**DOVER SCHOOL
DISTRICT**

JOINT BUILDING COMMITTEE – DOVER HIGH SCHOOL AND REGIONAL CTC MEETING NOTICE

**JOINT BUILDING COMMITTEE
DOVER HIGH SCHOOL AND REGIONAL CTC
MINUTES**

Owner's Change Order 0027

C 0- MUSIC - C - NORTH
OPTION 1 - 114sf

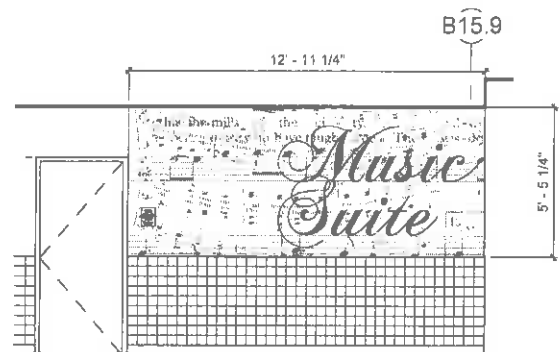
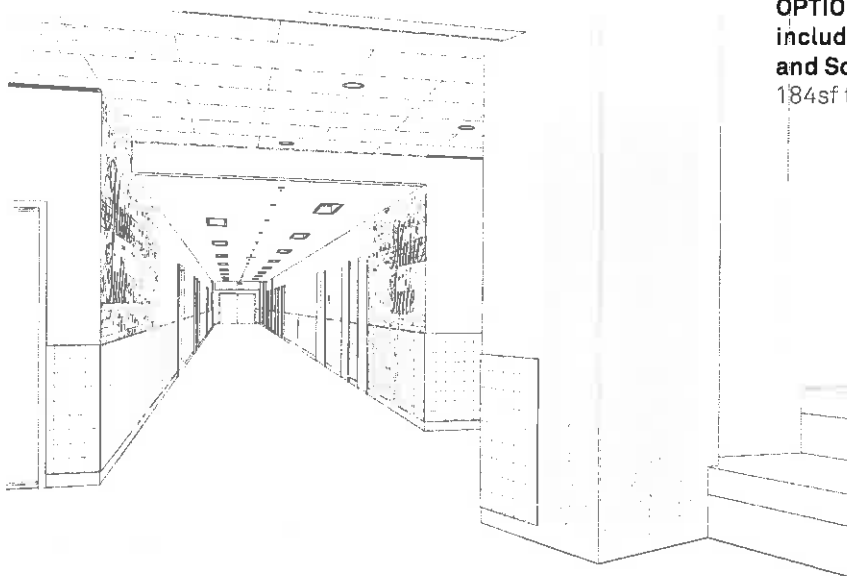
ADD GRAPHICS AT WELDING 135 PER THE ATTACHED SKETCH

Image Below Cropped from Drawing L2.4

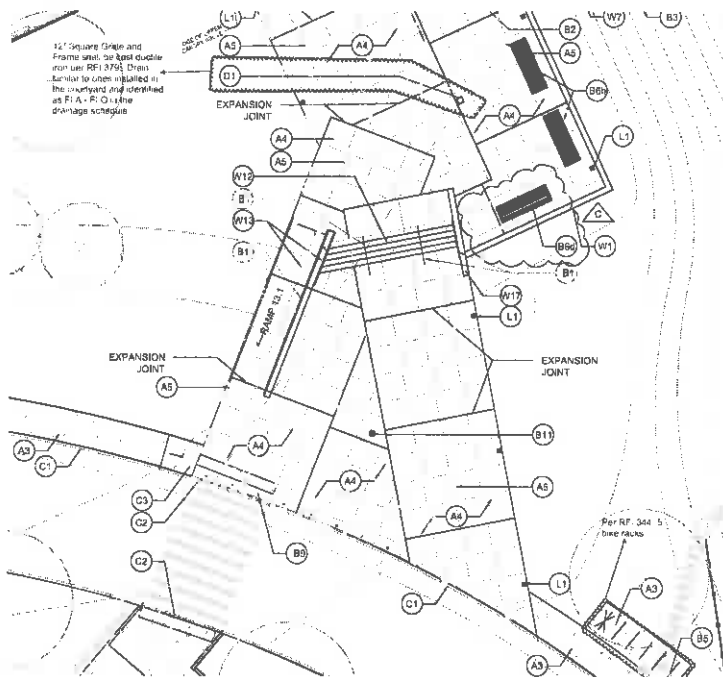
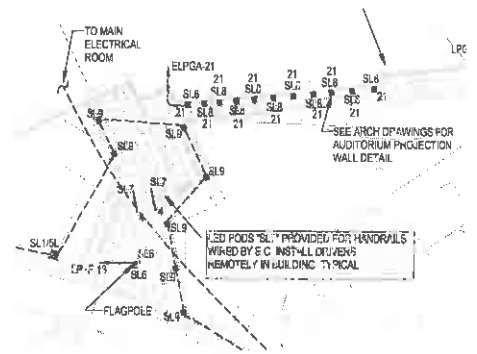
Electrical Drawing call out (2) Illuminated Handrails at the main entry stairs, symbol "SL7".

Please advise which is correct.

Electrical Drawing call out (2) Illuminated Handrails at the main entry stairs, symbol "SL7"..

Please advise which is correct.

Proposal to add lights to the handrails shown on L2.4 that were not shown on electrical drawings. This includes lighting at two handrails on the stairs and two handrails at the entry ramps as required per RFI-827.

~~Follow the L2.4 drawing. Electrical Contractor shall provide credit for the LED pods and provide connection to each hand rail that requires power for built-in lighting.~~

This would add lights to four handrails, this would be additional cost - not a credit. Scope confirmed with HMFH.

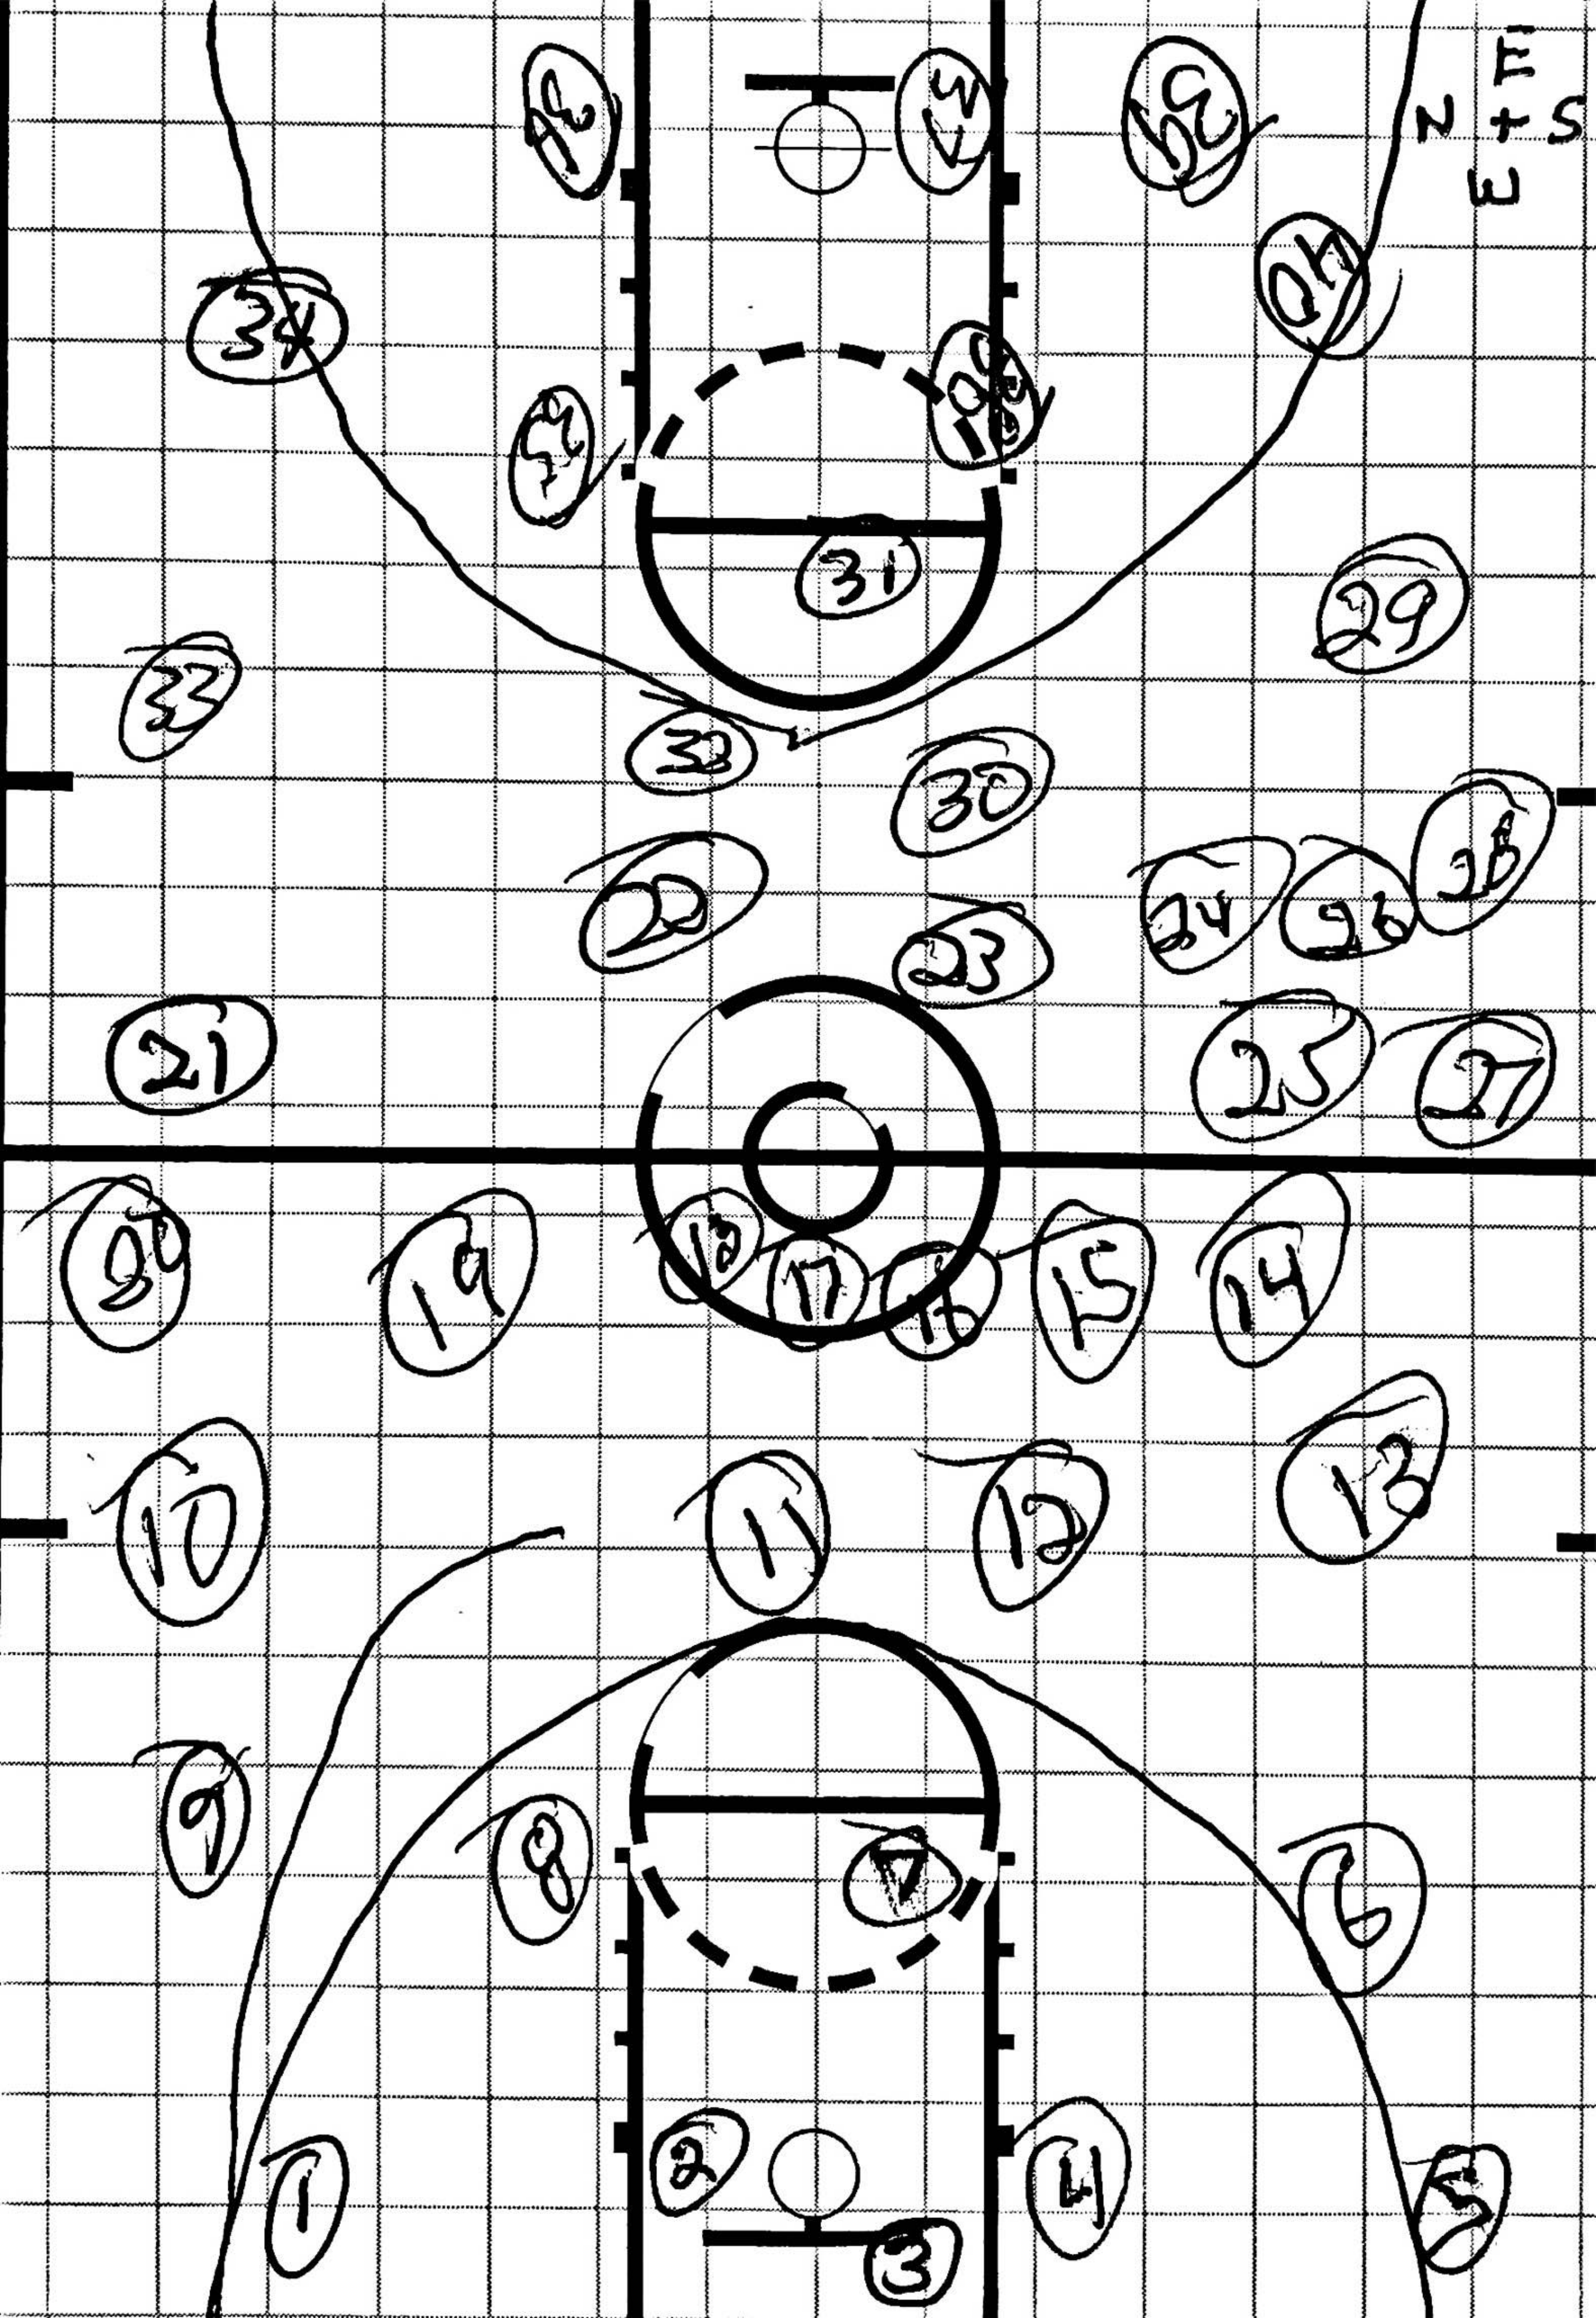
Sorry for the delay in responding regarding the action plan from PC Construction. MFMA did not find anything of concern in the action plan with the exception of the dead spot repair. Since the location of the dead spot is near a reported low spot and a volleyball sleeve, MFMA would recommend not repairing the dead spot until after the volleyball sleeves have been repaired. I have also included a map of the test locations as requested in the action plan.

Please see gym floor report with PC notes on direction we plan to take. Let me know if you have questions.
